# PRELIMINARY INFORMATION SHEET

PROJECT NAME: BENNINGTON  
 PROJECT NUMBER: ER BHF 010-1(45)  
 FILE NAME: z11b326\_pl.xls PLOT DATE: 8/21/2012  
 PROJECT LEADER: DEG DRAWN BY: KJK  
 DESIGNED BY: BTH CHECKED BY: SAW  
 PRELIMINARY INFORMATION SHEET SHEET 2 OF 40

THIS PROJECT INVOLVES THE RETROFITTING OF THE VERMONT ROUTE 9 BRIDGE 9 PIER FOUNDATIONS WITH MICROPILES IN THE TOWN OF BENNINGTON. THIS PROJECT DOES NOT INCLUDE ANY BRIDGE OR ROADWAY PAVEMENT REHABILITATION. THIS PROJECT WILL INVOLVE THE CONSTRUCTION OF TWO TEMPORARY ACCESS ROADS FROM VERMONT ROUTE 9 TO EITHER BRIDGE PIER.

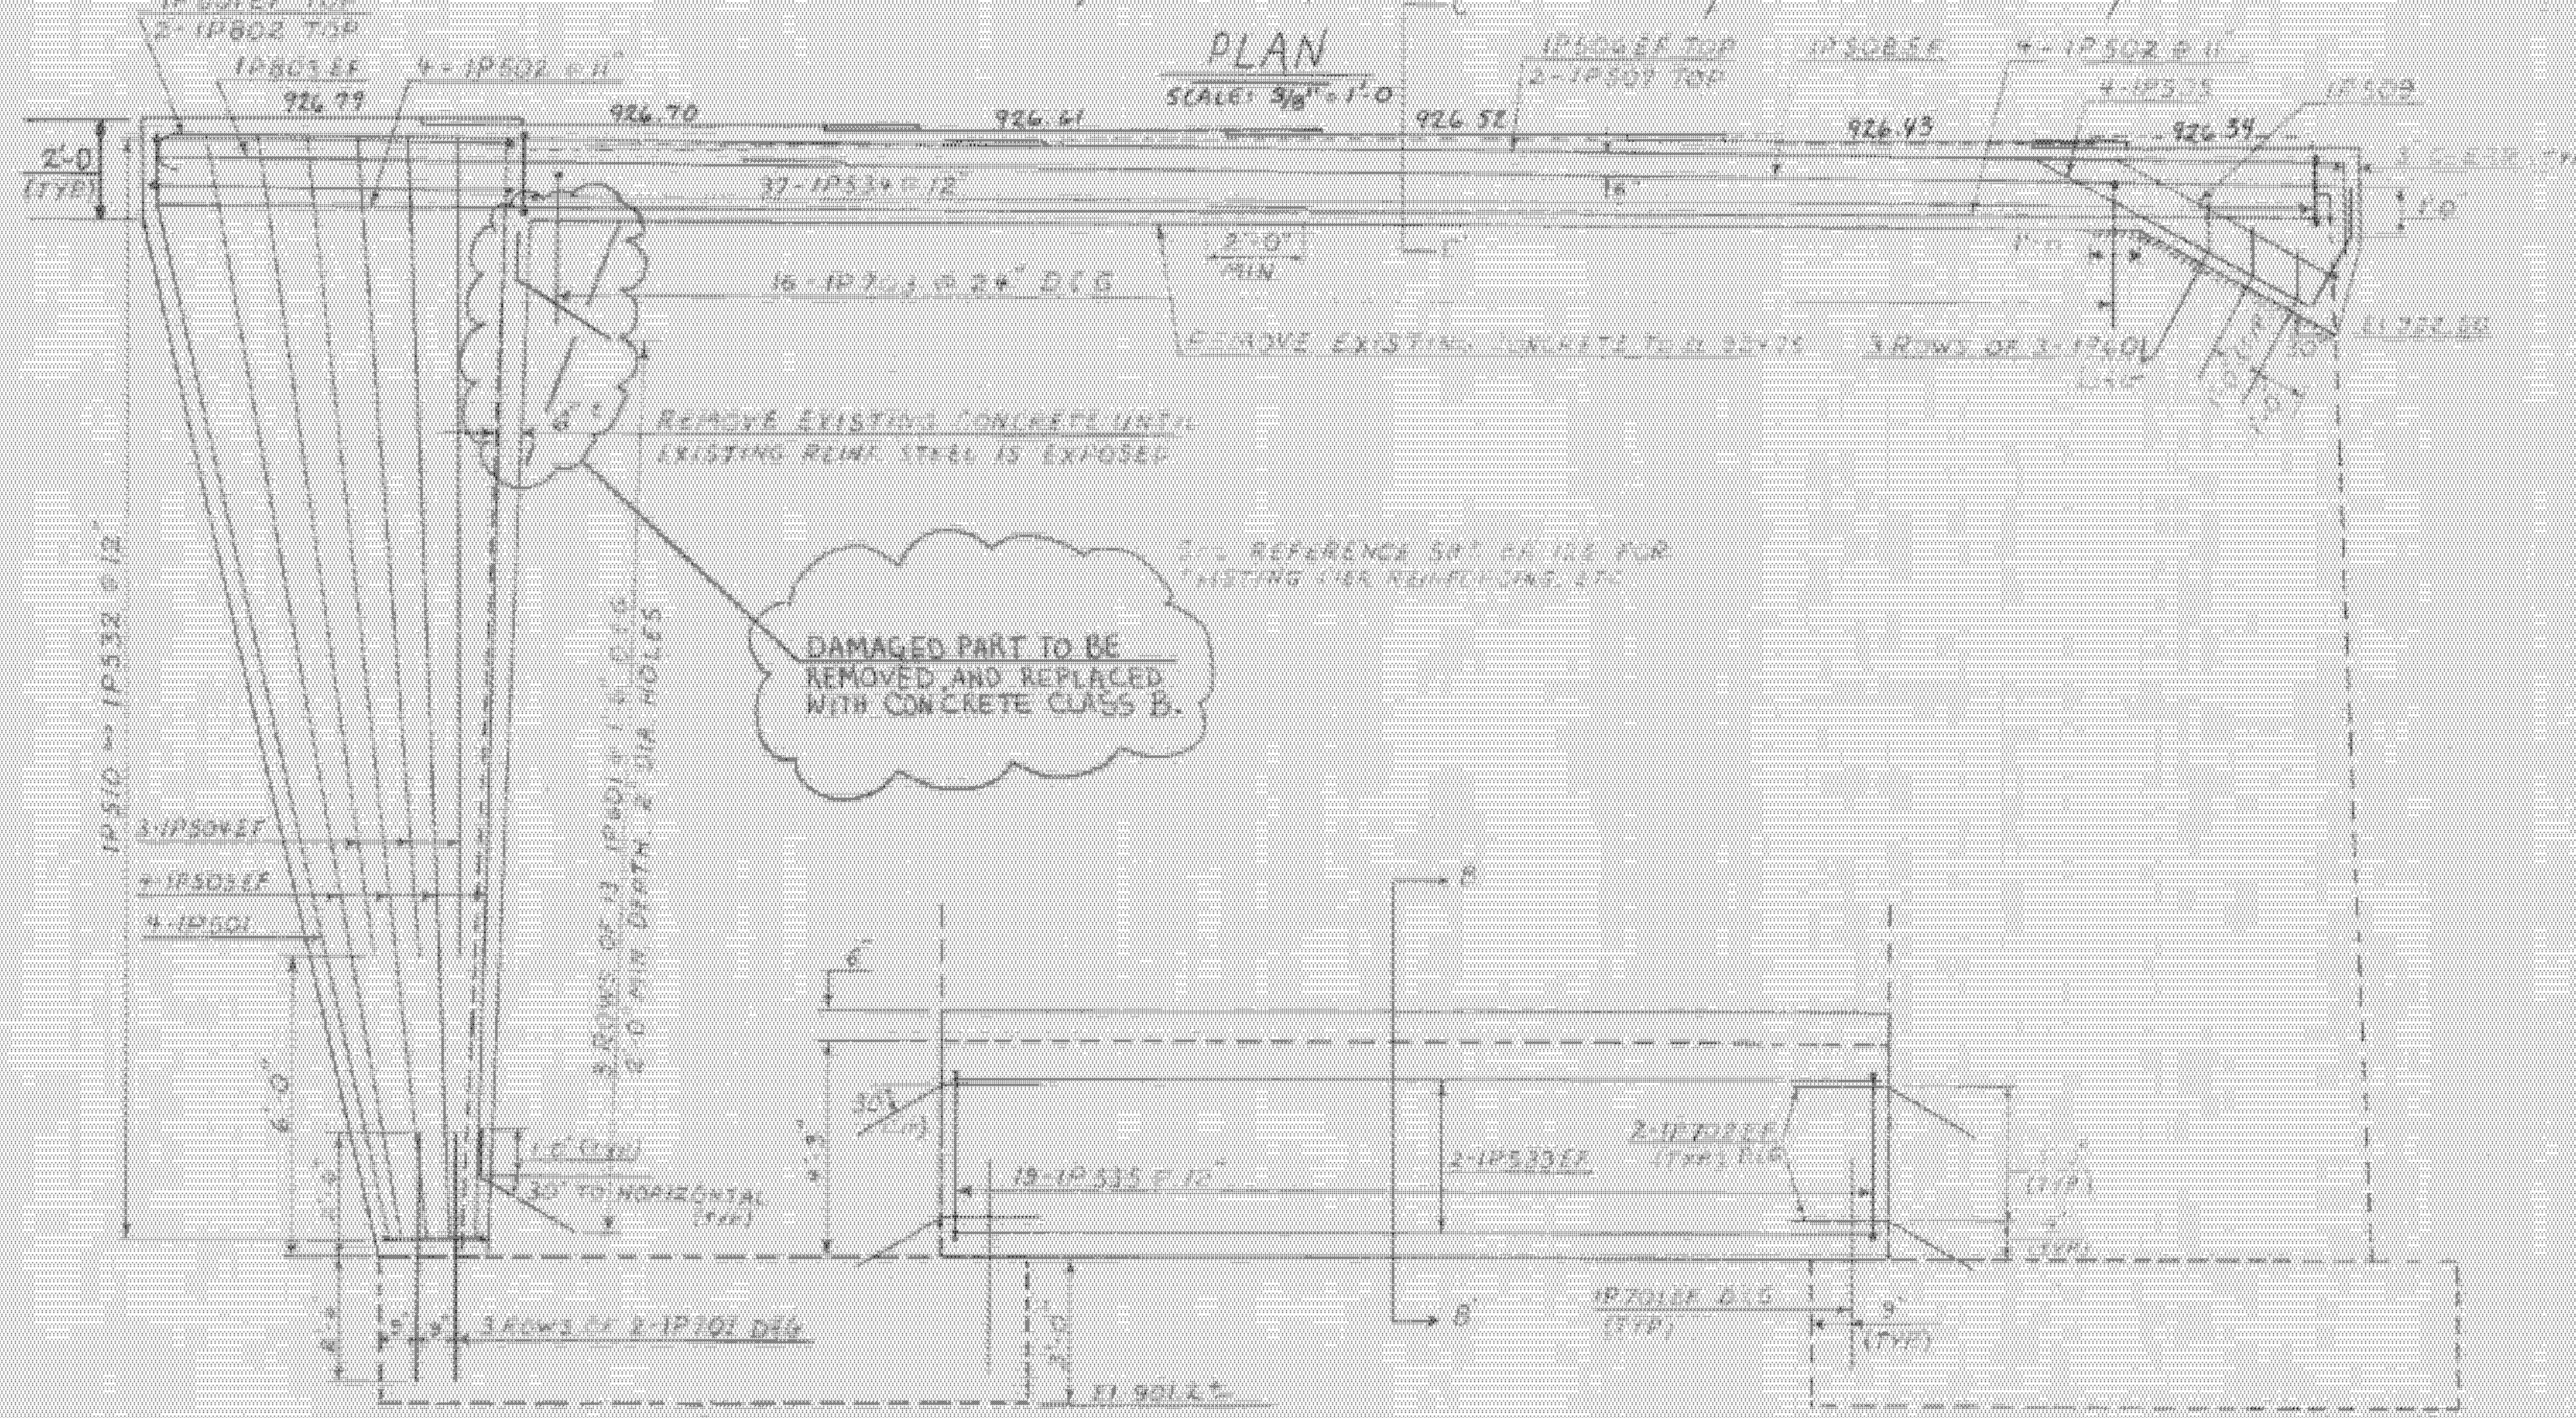
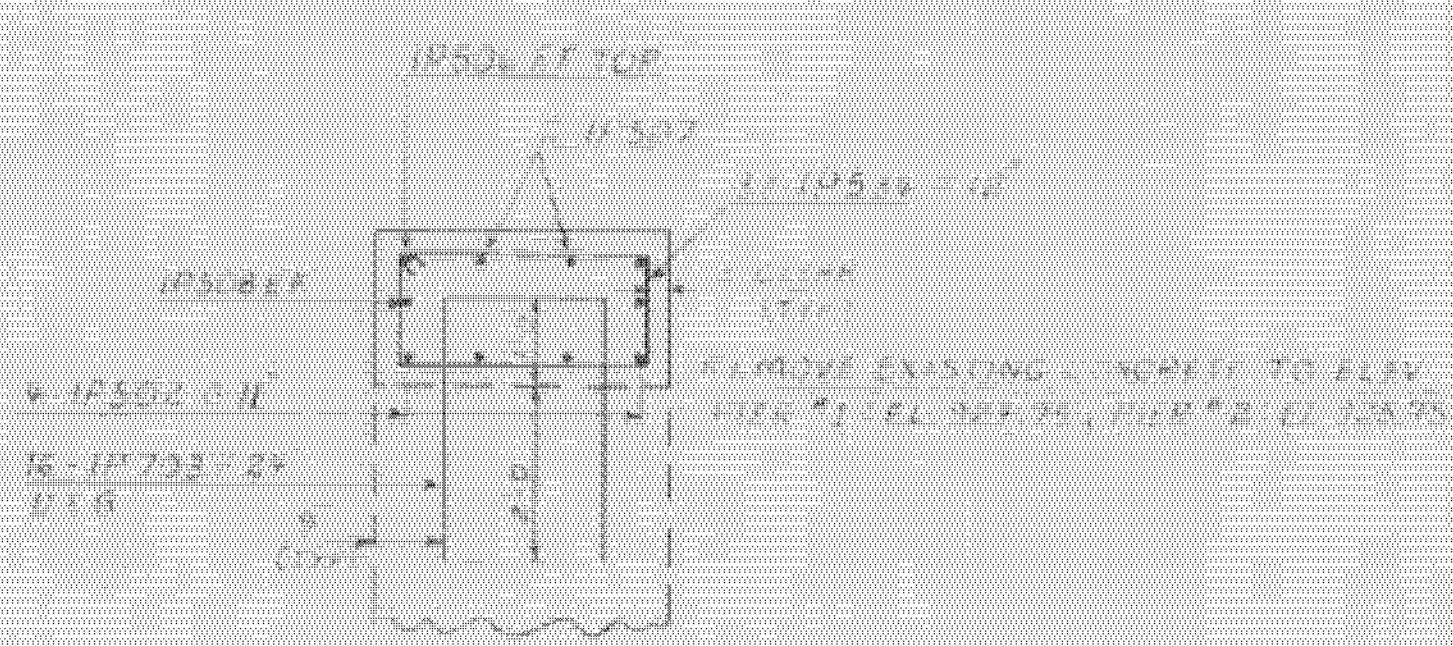
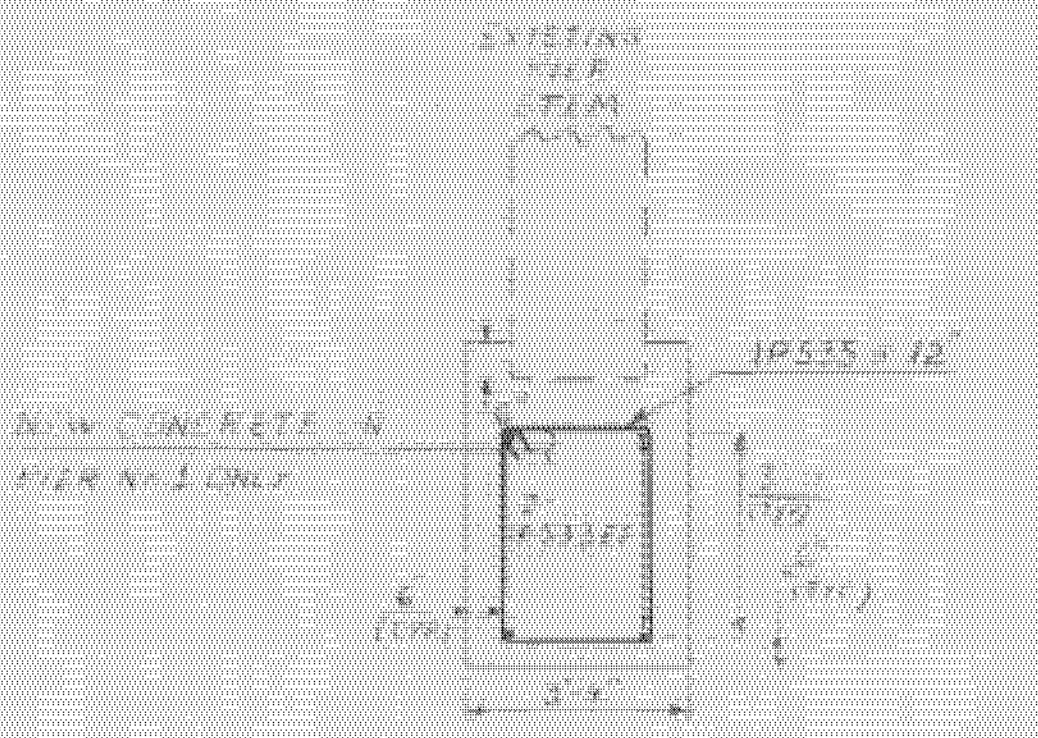
REVISED SHEET  
S. FARNSWORTH 4/88  
REVISION - REMOVAL  
OF DAMAGED CONCRETE  
AT DOWNSTREAM TOP  
CORNER OF PIER.
